**ADDENDUM NO. 1**

December 5, 2017

RE: **GRAFTON COUNTY COMMISSIONERS, NH  
FORCE MAIN REPLACEMENT**

FROM: DuBOIS & KING, INC.  
P.O. Box 339  
Randolph, Vermont 05060  
(802) 728-3376

**AIR RELEASE VALVE  
MANHOLE DETAIL**

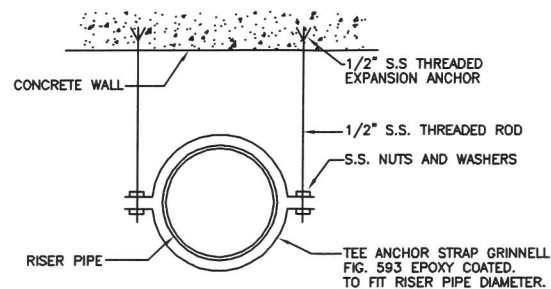
7. Sheet 7: **REPLACE** the Air Release Valve Manhole Detail with the attached SK-001. It is noted that the concrete manholes utilized for the Air Release Valve and the Force Main Blow-Off shall be tested in accordance with Specification Section 01666.
